Design Report #7

Thermal Mechanical Stress Analysis
of
High Pressure Injection Nozzle

B&W Contract No. 620-0003-50
Customer: Duke Power Company

Report #7 - "Thermal Mechanical Stress Analysis of High Pressure Injection Nozzle"

BADCOCK & WILCOX	BY C.W. ZINN
DEPARTMENT	
2 1/2" SCH 160 HIGH PRESSURE INJECTION NOZZLE	
28 IN. I.D. PIPE

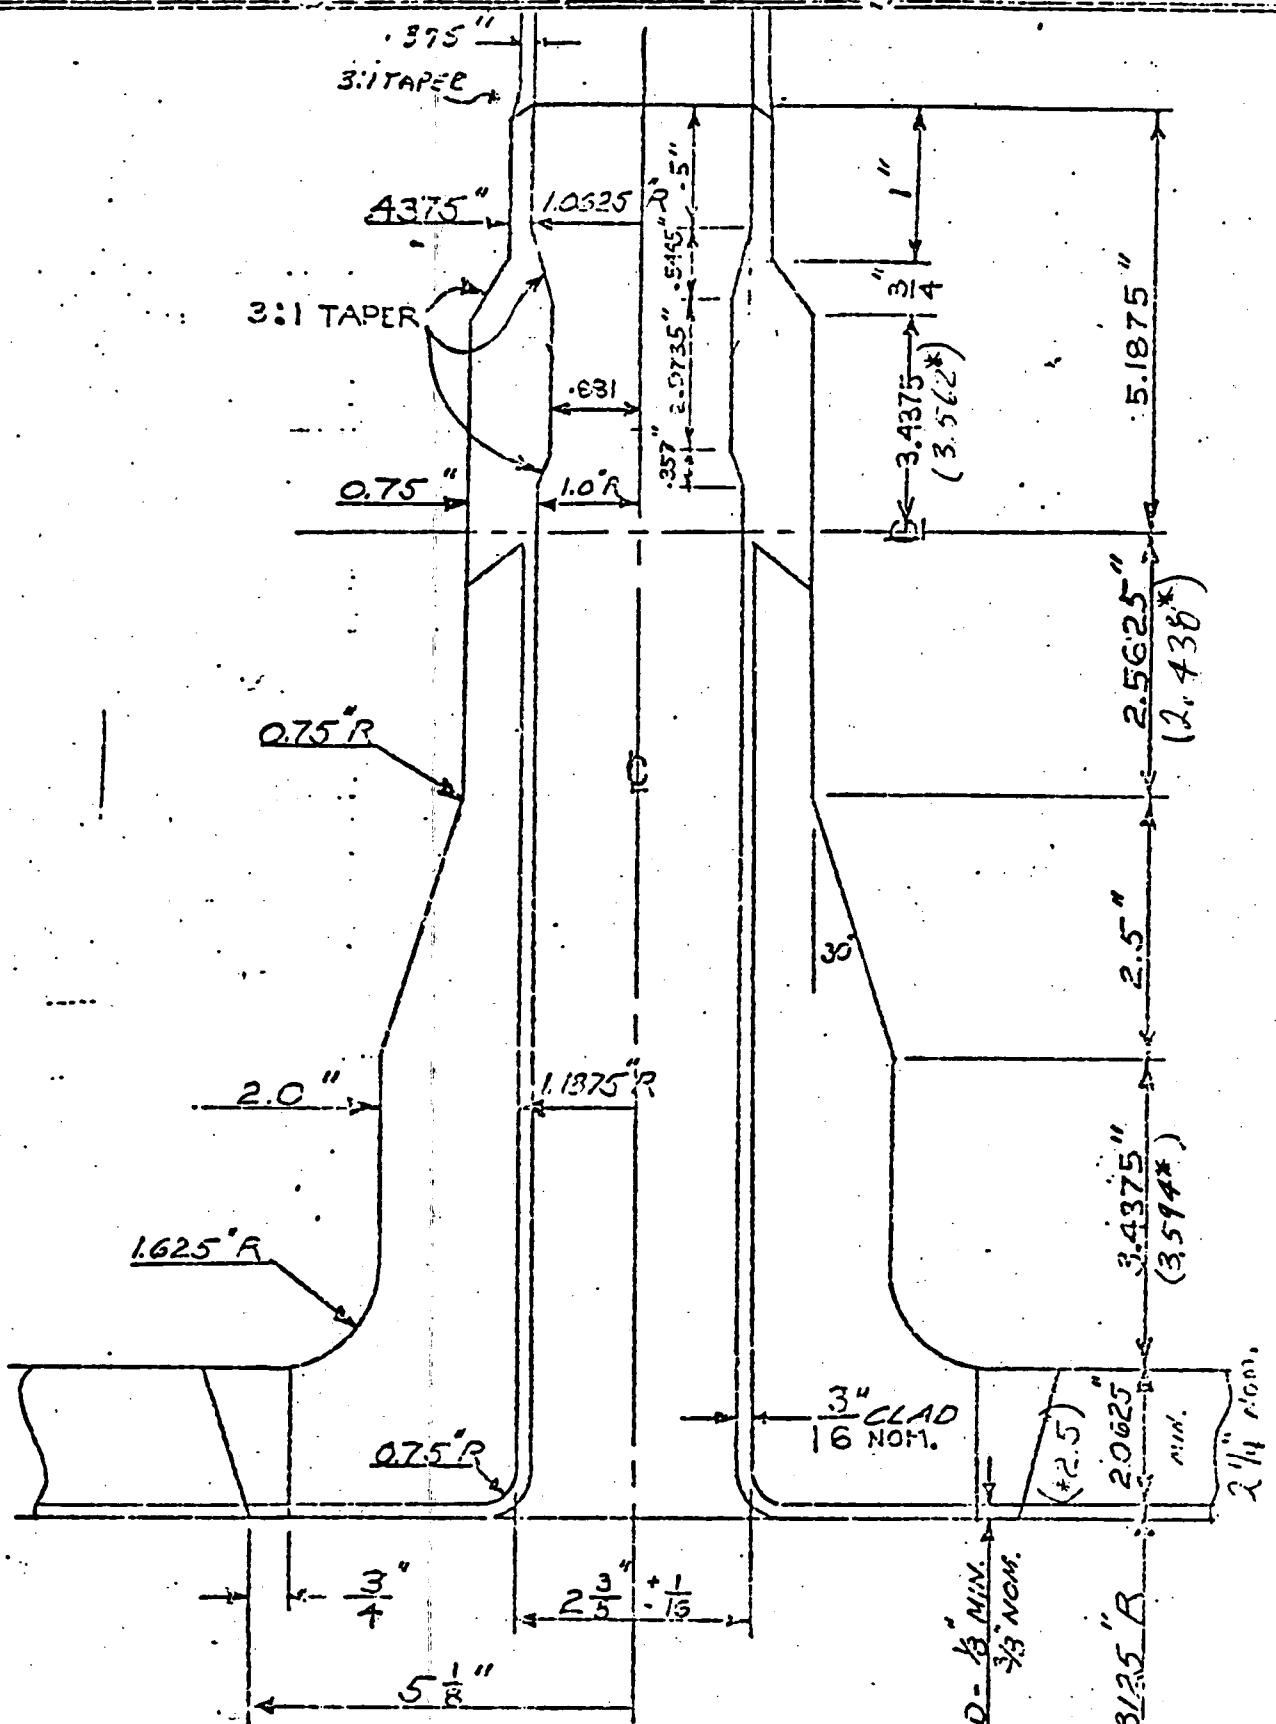
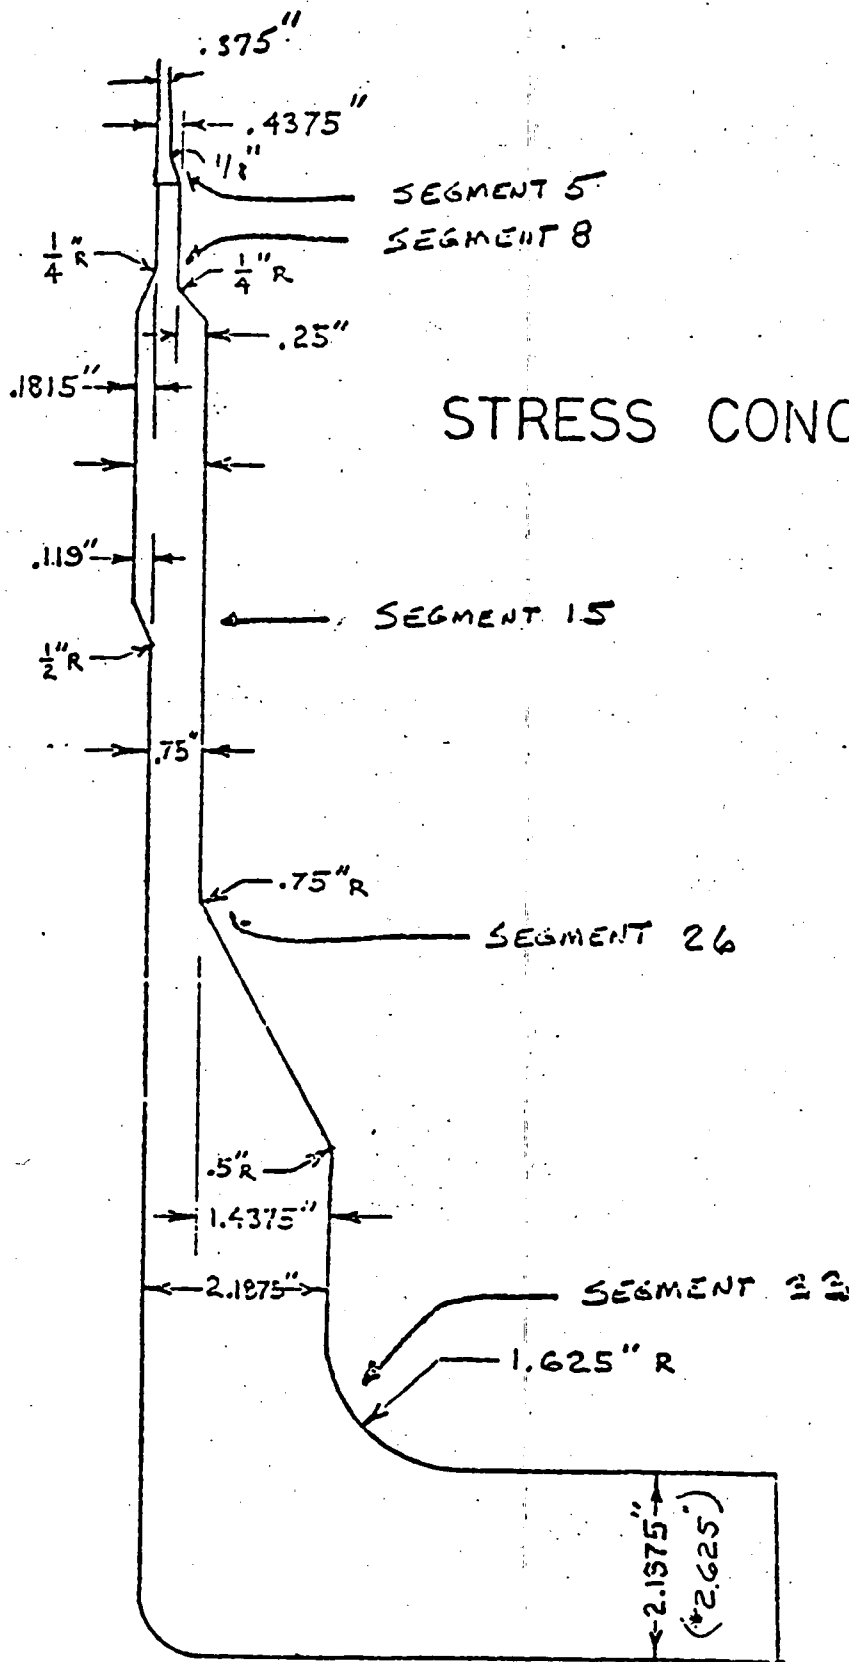
1.0	Added explanation for a dimensional change on nozzle.		
	1.1	Added NSS-9 dimensions (asteriked) to nozzle sketch.		
	3-56	Add statement at bottom of page.		
	3-65	Omitted Case-2 earthquake loading.		
	3-66	Omitted all reference to piping reaction stresses.		
1	5-21	Omitted all references to earthquake loadings.		
	5-22 to 5-31	Omitted all reference to piping reaction stresses.		
	ii	Added note referencing fatigue analysis with pipe loads contained in Section "F".	10/29/73	DMcK/br3
	5-21			
	5-24			
	5-25			
	5-28			
	5-29			
	5-30			
	5-31
